ROM w/ BASIC upgrade

Upgrade the onboard ROM to EXOS 2.4, which have built-in BASIC.
One 64Kb 27C512 (E)EPROM needed, and one wire needs soldering. Solder a wire onto the EPROM **PIN1** (bend the pin up so it doesn't go into the socket) and solder the other end to the **A15** address line.

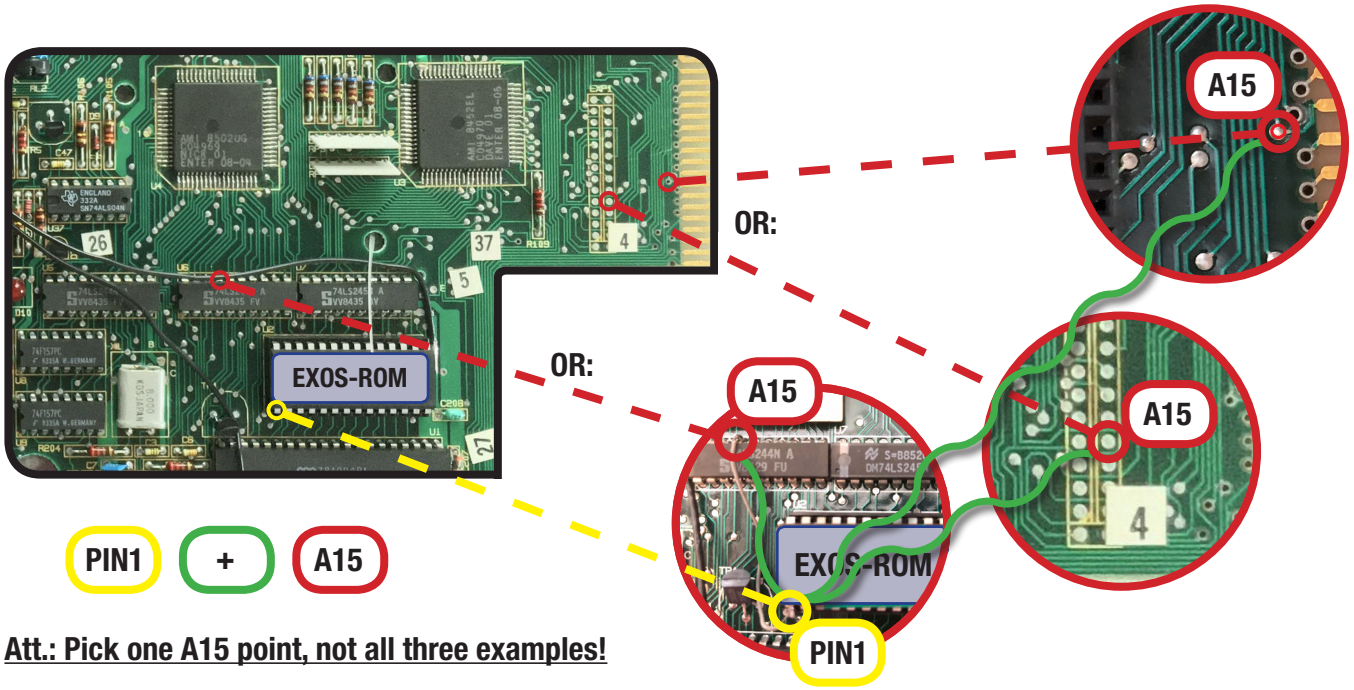
Att.: Pick one A15 point, not all three examples!

GROUNDING / GND patch

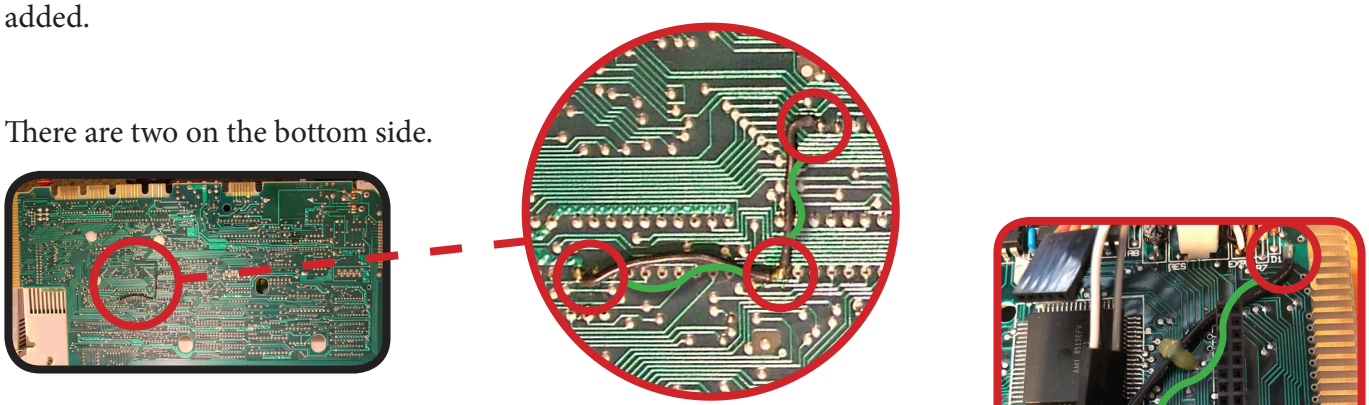
GND patch wires; These are missing from most of the EP64 machines. The EP128 machines had these added.

There are two on the bottom side.
